Groundwater Application Review Summary Form

Application # G- 18860

PUBLIC INTEREST REVIEW FOR GROUNDWATER APPLICATIONS

TO: Water Rights Section
 FROM: Groundwater Section Travis Brown Date 1/3/2020
 Reviewer's Name
 SUBJECT: Application G- 18860 Supersedes review of _____
 Date of Review(s) _____

Stream Depletion Analysis
POA 1 – SW 1

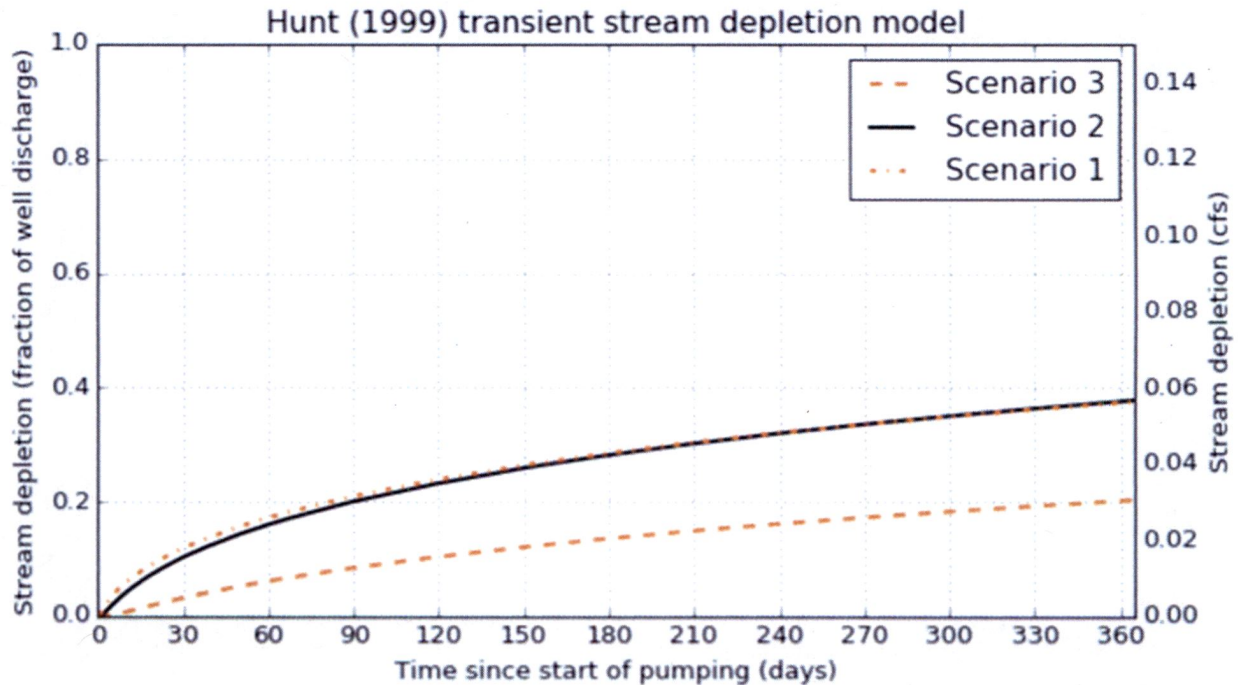
Model results indicate that the proposed use is unlikely to cause depletion of (interference with) either SW 1 or SW 2 greater than 25 percent of the proposed pumping within the first 30 days of pumping (see attached Stream Depletion Analyses). However, stream depletion will increase with additional pumping over time.
